Lake County Department of Public Works
Saunders Road Sanitary Sewer and Lift Station Improvements
Bid #26142
Project #2020.130
Addendum #1 – March 13, 2026

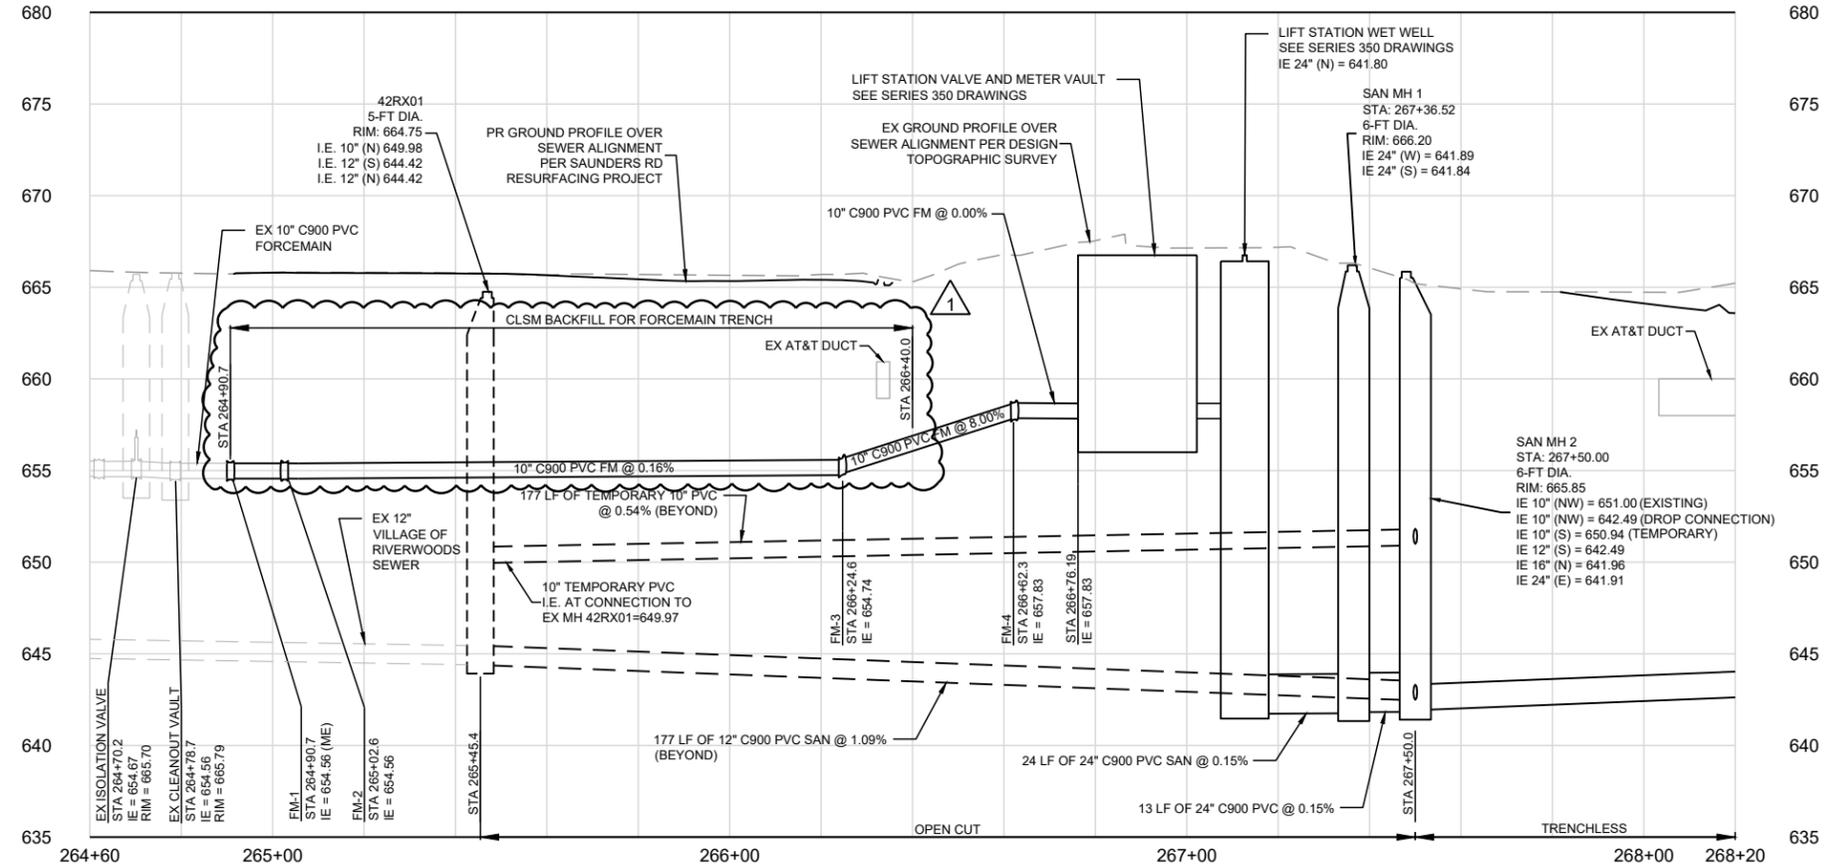
Answer: A pay item for CLSM backfill will not be added. CLSM backfill is only required in trenches where new piping extends beneath the proposed roadway pavement of Saunders Road that will be installed per the Saunders Road Resurfacing Project. Locations where CLSM backfill is required are specifically noted on the 002-CP Drawings reissued as part of this addendum.

- PLAN NOTES:**
- CONSTRUCT SANITARY MANHOLE PER C200.
 - PROVIDE DROP CONNECTION FOR 10-INCH PVC SEWER AT SAN MH 2 PER C240 OR C242.
 - 12-INCH C900 PVC SANITARY SEWER AND TEMPORARY 10-INCH SDR 21 PVC SANITARY SEWER. (TEMPORARY 10-INCH PVC SEWER ABOVE 12-INCH PVC SEWER ALONG SAME ALIGNMENT.) ABANDON TEMPORARY 10-INCH PIPING AND PLUG AT SAN MH 2 AND MH 42RX01 PER C266 AFTER NEW LIFT STATION AND GRAVITY SEWER WORK IS COMPLETE. SEE SECTION 01 11 00 FOR CONSTRUCTION SEQUENCING INFORMATION.
 - CONNECT NEW FITTING TO EXISTING FORCEMAIN.
 - CLSM BACKFILL REQUIRED FOR PORTIONS OF NEW FORCEMAIN LOCATED BENEATH SAUNDERS ROAD ROADWAY PAVEMENT. SEE PROFILE FOR APPROXIMATE STATIONING.

LAKE COUNTY DEPARTMENT OF PUBLIC WORKS
SAUNDERS ROAD SANITARY SEWER
AND LIFT STATION IMPROVEMENTS
BID #26142 PW #2020.130
LAKE COUNTY, IL
CIVIL
GRAVITY SEWER PLAN AND PROFILE

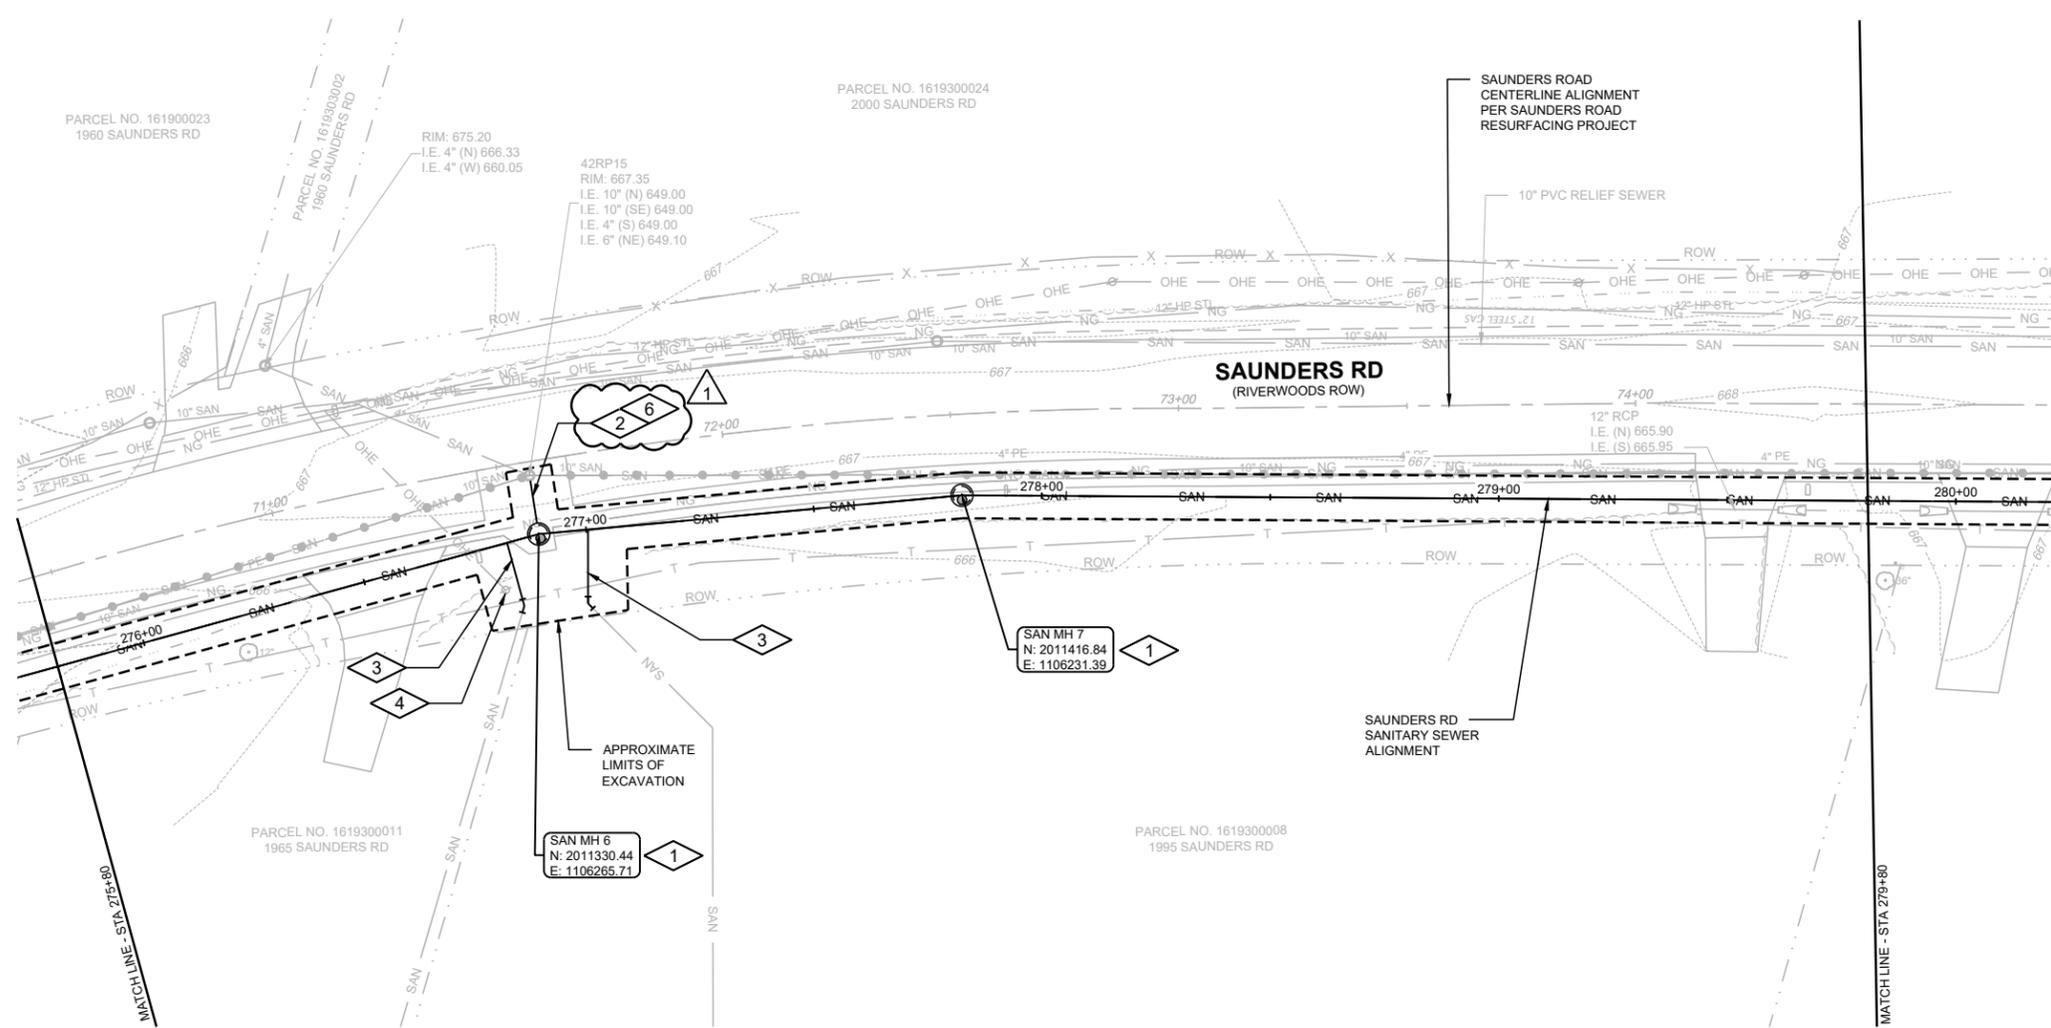
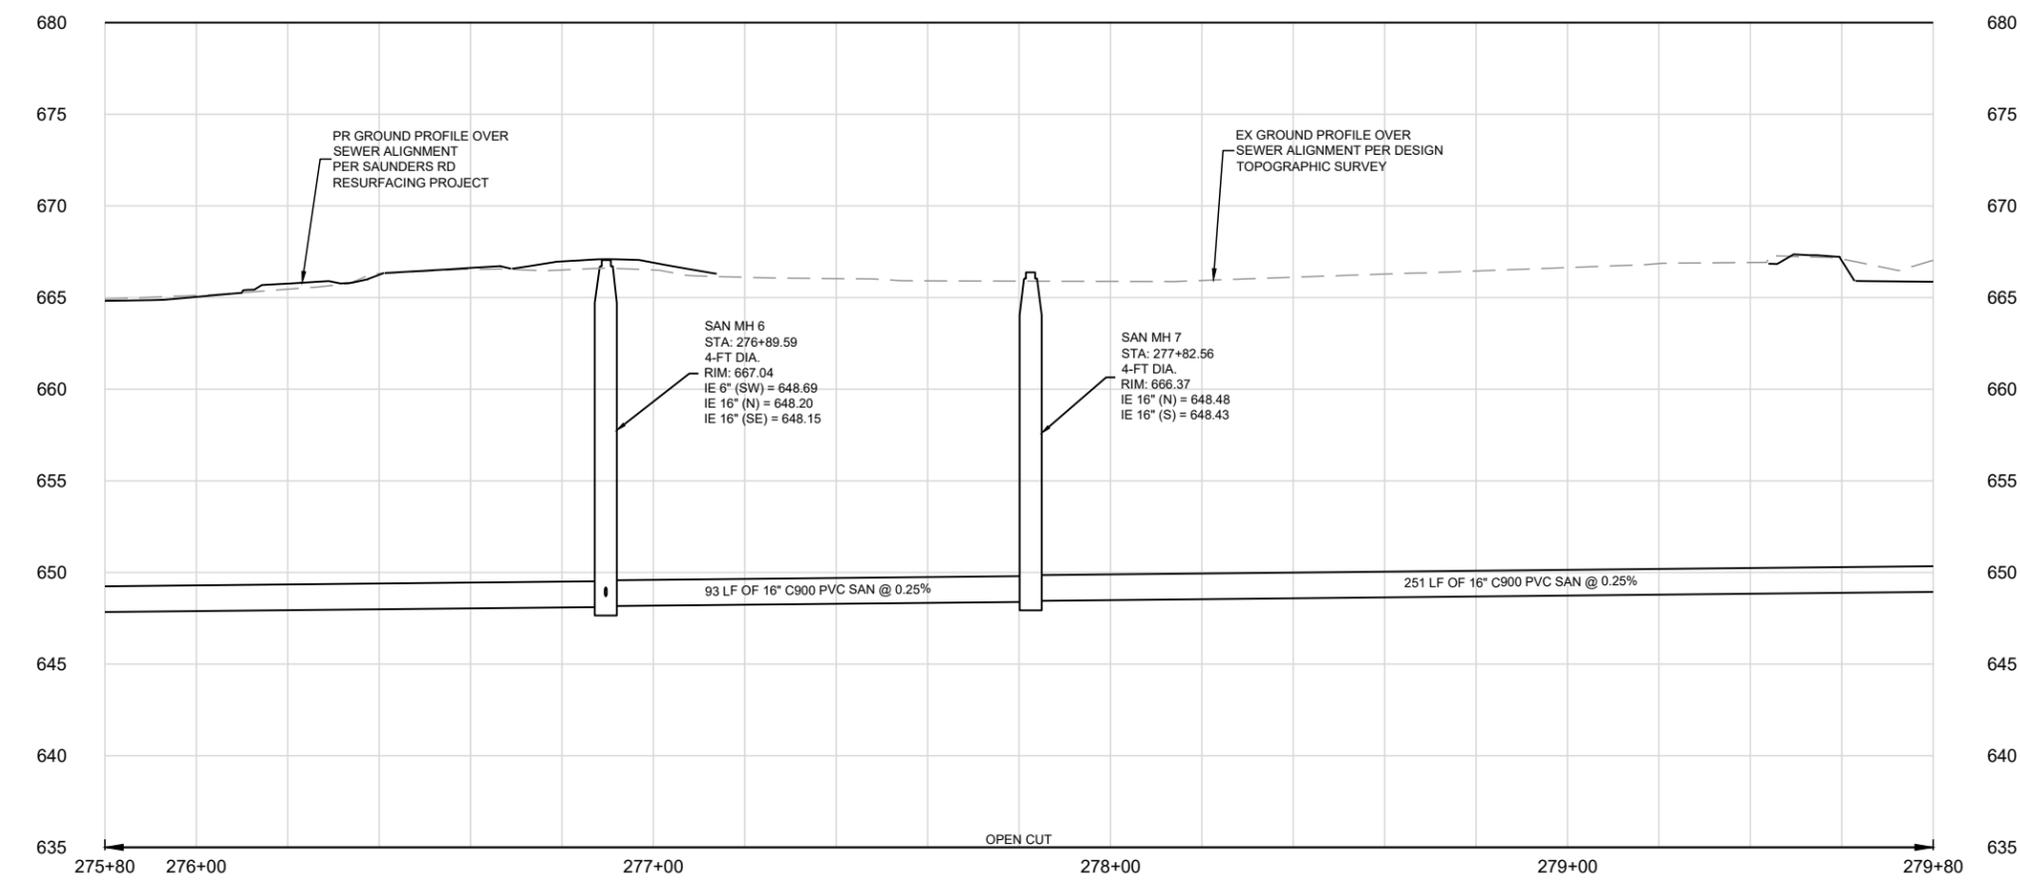
- PROVIDE ASPHALT APRON FOR MANHOLE COVER LOCATED WITHIN AGGREGATE SHOULDER PER C135.
- CLSM BACKFILL REQUIRED FOR PORTIONS OF NEW PIPING THAT EXTEND BENEATH SAUNDERS ROAD ROADWAY PAVEMENT.

PIPE BEDDING AND TRENCH BACKFILL (LCPW STANDARD DETAIL 3) C501

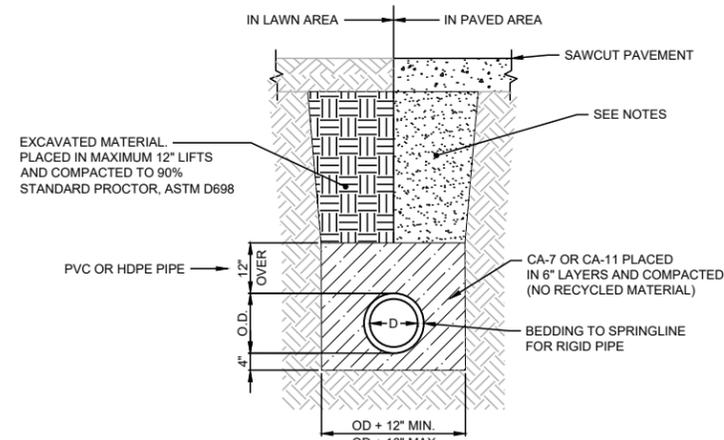
- CONFIRM REQUIREMENTS OF LOCAL MUNICIPALITY AND ROADWAY AUTHORITY REGARDING THEIR SPECIFIC BEDDING AND BACKFILL MATERIAL STANDARDS.
- FLOWABLE FILL / CONTROLLED LOW STRENGTH MATERIAL (CLSM), MIX 3 PER ARTICLE 1019.05 OF THE IDOT STANDARD SPECIFICATIONS REQUIRED IN TRENCHES WHERE NEW PIPING IS LOCATED BENEATH ROADWAY PAVEMENT ON SAUNDERS ROAD. THESE AREAS ARE NOTED ON THE PLANS.
- GRANULAR FILL (CRUSHED STONE, IDOT GRADATION CA-6) REQUIRED IN ALL OTHER TRENCHES EXTENDING BENEATH PAVEMENT, SHOULDERS, DRIVEWAY, SIDEWALKS, EQUIPMENT PADS, AND CURB & GUTTER.

“C. Granular Fill: Within trenches beneath pavements, shoulders, driveways, sidewalks, equipment pads, and curb & gutter not otherwise indicated to receive CLSM backfill.”

“E. Controlled Low Strength Material (CLSM)/Flowable Fill: Within trenches where new piping extends beneath roadway pavement on Saunders Road. These locations are noted on the Drawings.”
